Duane Arnold Energy Center

Response to Request for Additional Information Related to the Relief Request for 3rd
Period Limited Weld Examinations

**Response to Request for Additional Information (RAI) Related to the Relief
Request for 3rd Period Limited Weld Examinations**

**2.1 Request for Relief, Examination Category B-D, Item B3.90, Full
Penetration Welded Nozzles in Vessels**

JPB 2001

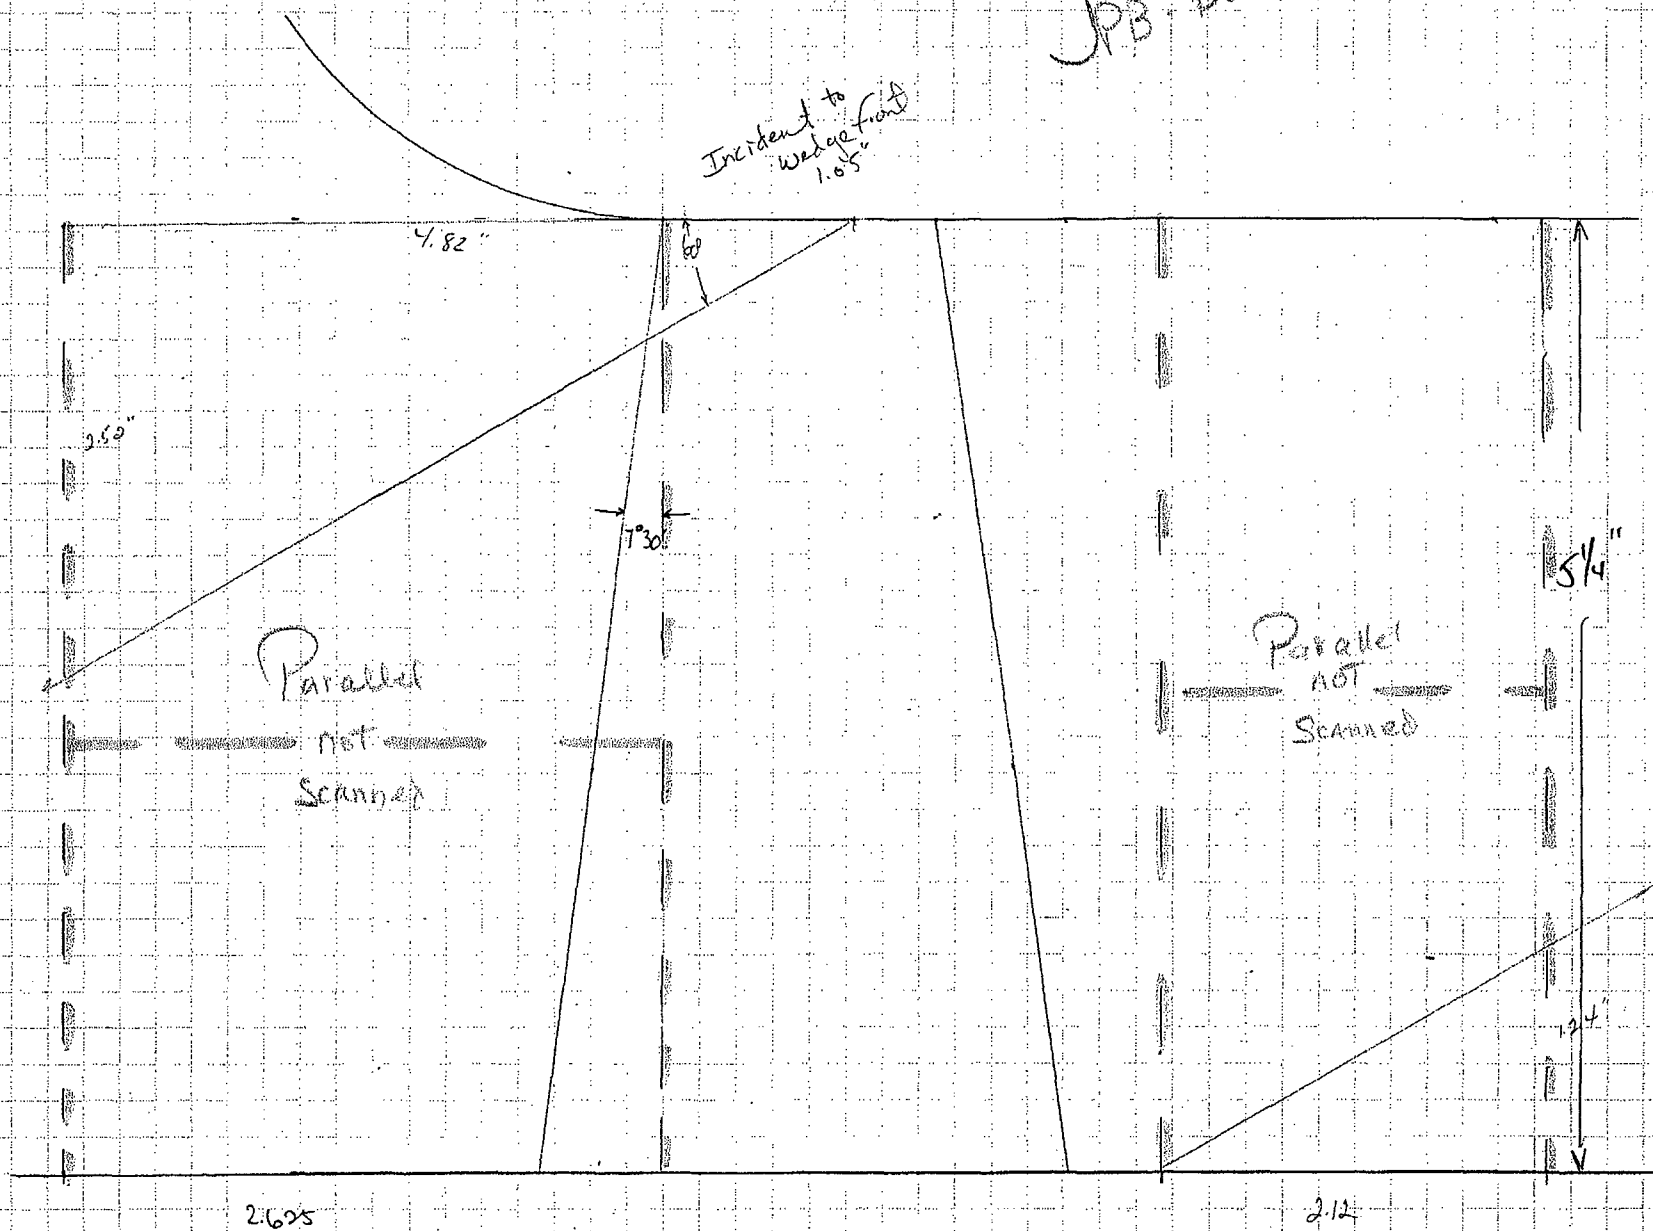
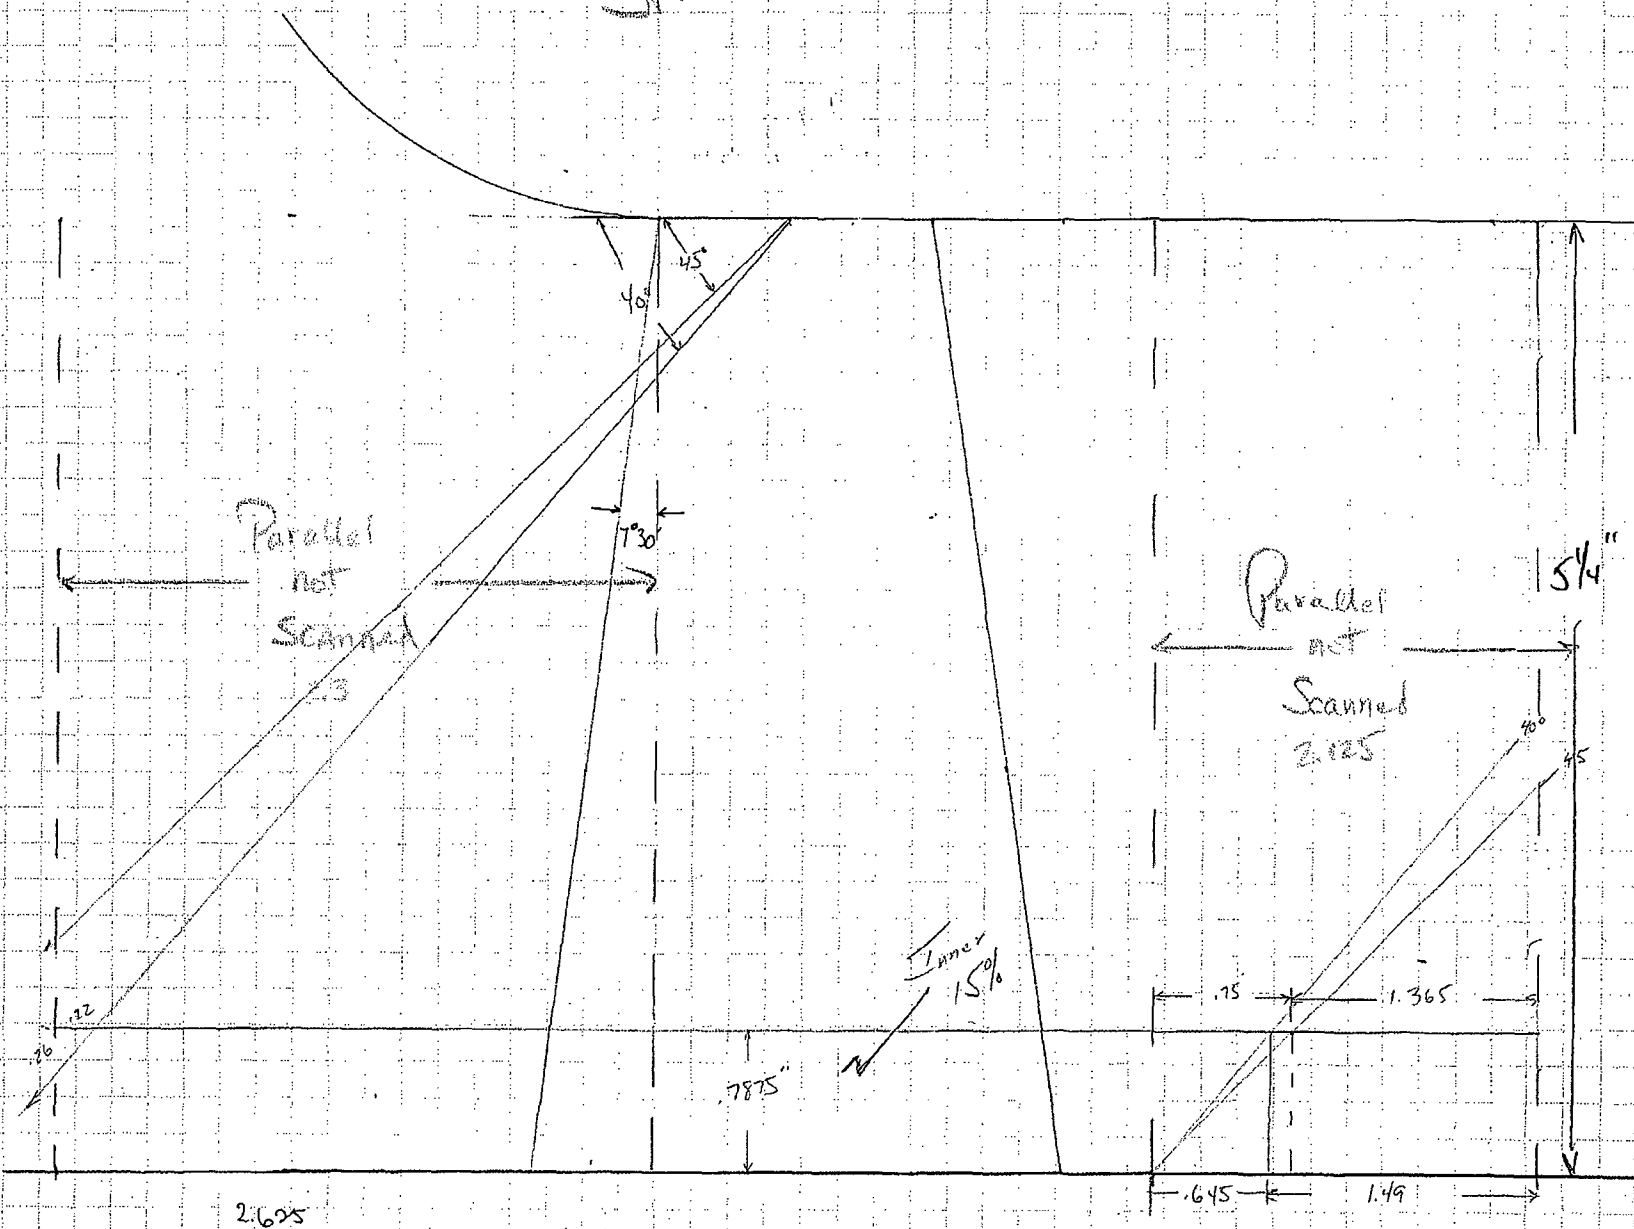
- a. *Provide a detailed description of examination limitations including access requirements for automated or manual ultrasonic techniques employed, and a description of each component geometry that restricts or limits examinations. The technical bases should include cross-sectional sketches of the weld indicating ultrasonic coverage(s) for each technique employed and details of the weld and base metal materials.*

For nozzle JPB-D001, the examination is additionally limited due to an insulation bracket welded on the vessel. Removal of this bracket is not feasible due to the fact that it supports the lower ring of RPV insulation.

DWG. NO. CORE DIFF. PRESSURE & LIQUID
CONTROL NOZZLE MK 3110
REV.

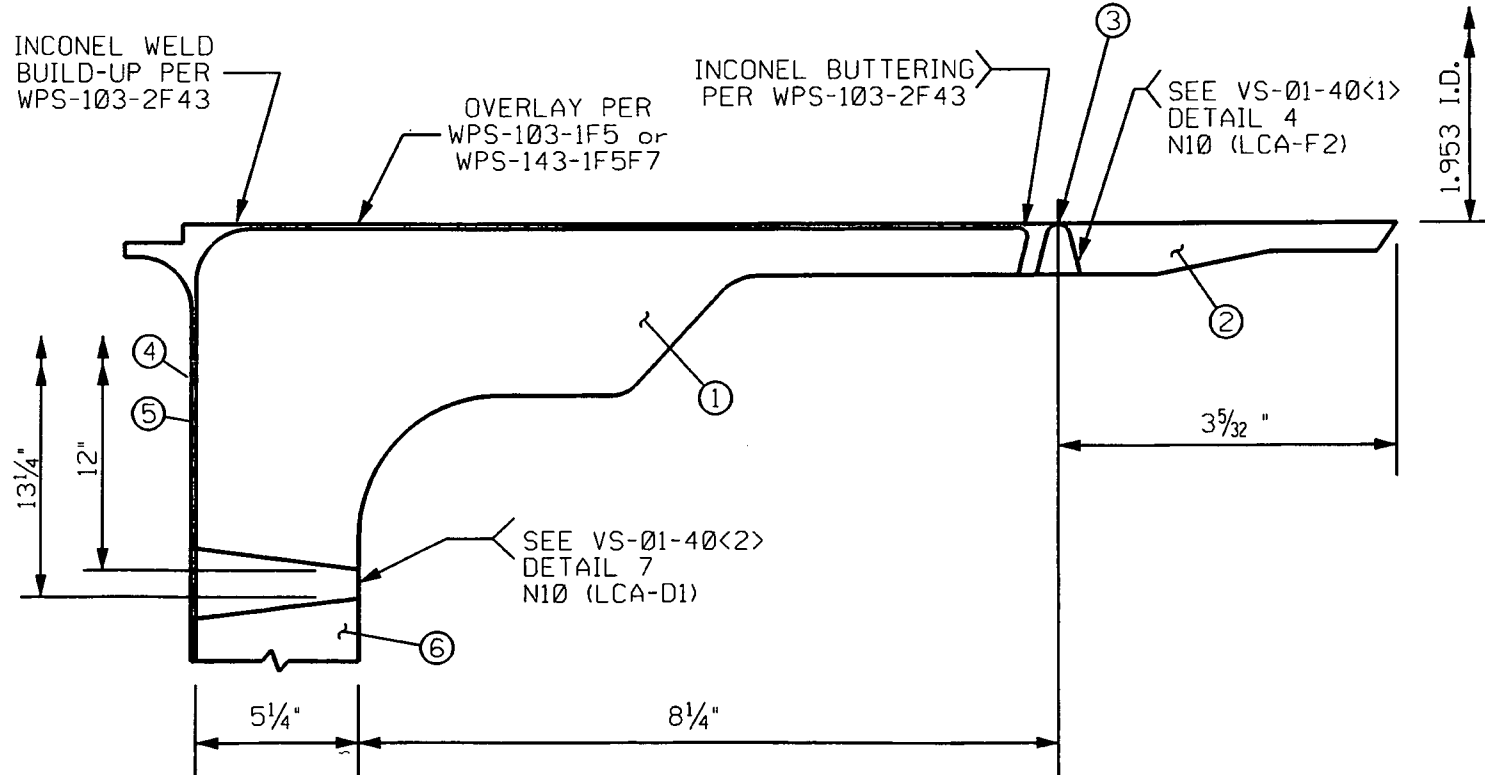
2.2.1 *The licensee stated that the proximity of the RPV skirt weld obstructed access for performing the inner radius section examination on Standby Liquid Control Nozzle LCA-D001. However, this statement does not provide adequate descriptive information and technical discussion to support a determination of impracticality and that the required examination was performed to the maximum extent possible at DAEC.*

- a. *Provide a detailed description of examination limitations including access requirements for automated or manual ultrasonic techniques employed, and a description of the component geometry that restricts or limits the examination. The technical basis should include cross-sectional sketches of the inner radius section indicating ultrasonic coverage for each technique employed.*

A description of examination limitations for performing the UT on the inner radius section on Standby Liquid Control Nozzle LCA-D001 is included for review as Enclosure 3. The configuration of the nozzle and a photo indicating the proximity of the nozzle to the skirt is also included for review. The request for additional information included a request for cross sectional sketches of the inner radius section. Since the limitation is due to the skirt welded to the vessel and not the configuration as it was on the nozzle-to-vessel welds discussed above, a cross-sectional view is not warranted. To clarify, the skirt limits the surface contact area of the transducer.

The manual ultrasonic techniques employed were as recommended in the EPRI modeling Report IR-2004-62. The techniques utilized were limited by the proximity of the weld attaching the Skirt Knuckle to the RPV bottom head. The supplied photo in Enclosure 3 shows that the nozzle is located close (approximately six inches) to the skirt weld.

COMPONENT ID NO: HEA-CA-5

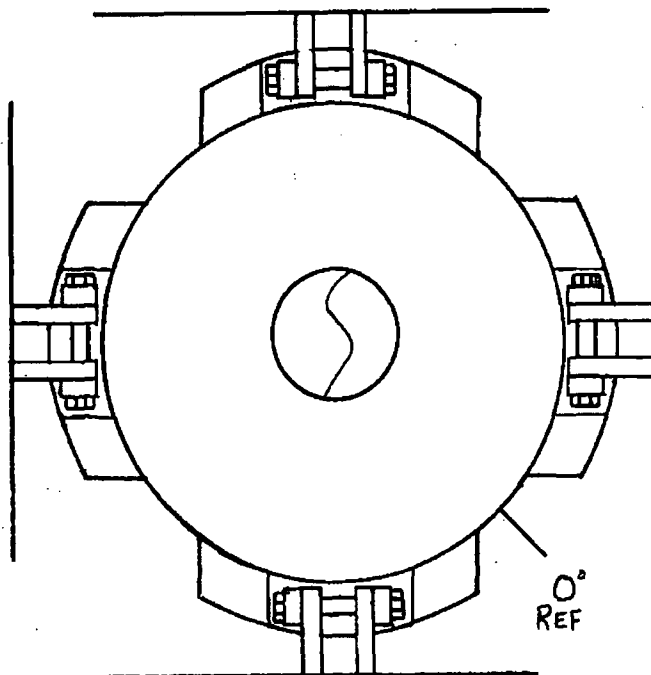
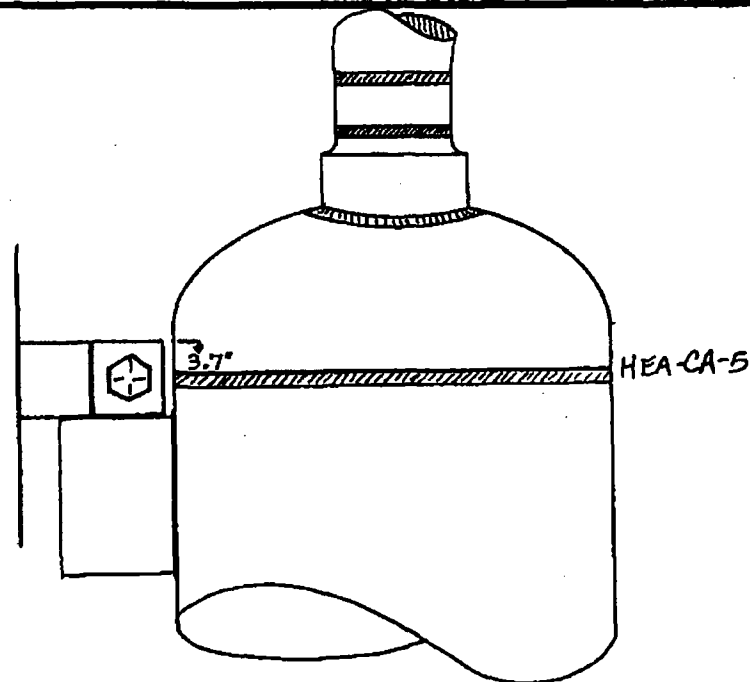
- 2.4.1 *The license stated that heat exchanger tie-down brackets obstruct access to the subject head-to-shell weld, limiting examination coverage. However, this statement does not provide adequate descriptive information and technical discussion to support a determination of impracticality and that the required examination was performed to the maximum extent possible at DAEC.*
- a. *Provide further text and/or a cross-sectional sketch describing the basis for impracticality and showing volumetric coverage for Weld HEA-CA-05. In addition, state or show the material, thicknesses, and outside diameters for the subject component. Discuss why the tie-down brackets cannot be removed to allow greater access.*

Examination Category	Item Number	Component Number	Period Examined	Code Coverage	Description
C-A	C1.10	HEA-CA-01	3	94%	RHR Heat Exchanger Tube Sheet to Shell Weld
C-A	C1.10	HEA-CA-03	1	100%	RHR Heat Exchanger Shell Course Weld
C-A	C1.20	HEA-CA-05	2	78.07%	RHR Heat Exchanger Head to Shell Weld
